**APPLICATION FOR SEPTIC SYSTEM PERMIT
FLOYD COUNTY HEALTH DEPARTMENT**

PERMIT NO. 980xxxx 98-009

RE: Soil Survey Submittal
Hillside Professional Center
Section 18, T25, R6E.
Floyd County

INDIANA STATE DEPARTMENT OF HEALTH TECHNICAL DATA SHEET FOR FLOOD-DOSING SYSTEM

HILLSIDE PROFESSIONAL CENTER
PLOT PLAN

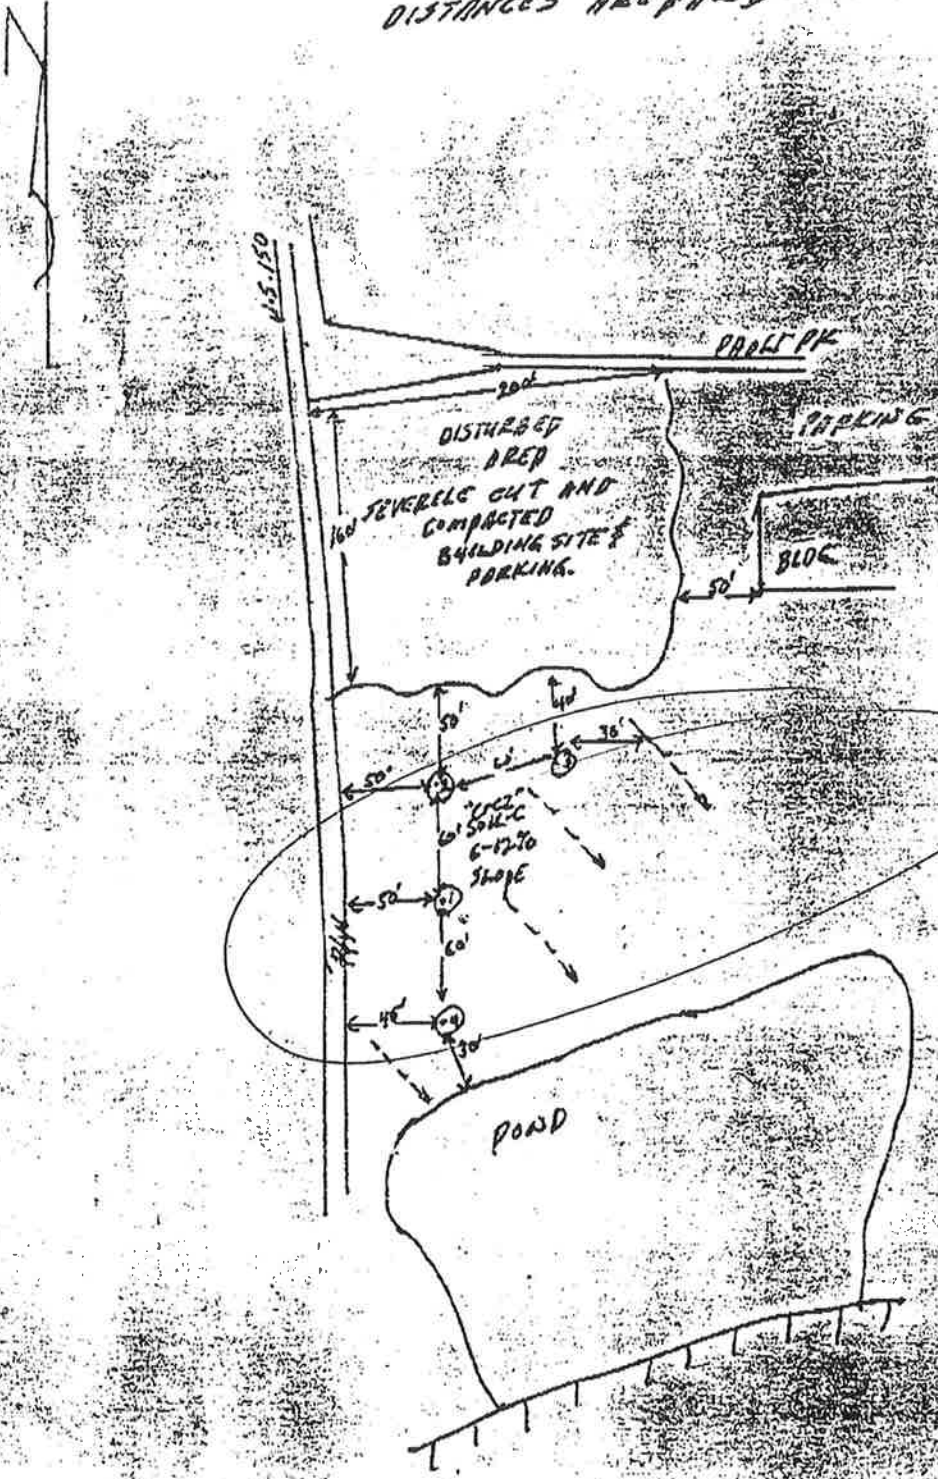
Applies to Soil Report for northern site

A single submersible effluent pump is required in the dosing tank. Show the route, diameter, material (including ASTM number for PVC materials), and slope of the force main from the dosing tank to the distribution box. To prevent direct discharge to any outlet, specify a baffle or a downturned 90° elbow in a cross-sectional view of the distribution box. The baffle or elbow shall terminate no more than 2 inches above the bottom of the box. Locate the distribution box at the high side of the absorption field to allow gravity flow from the box to each trench.
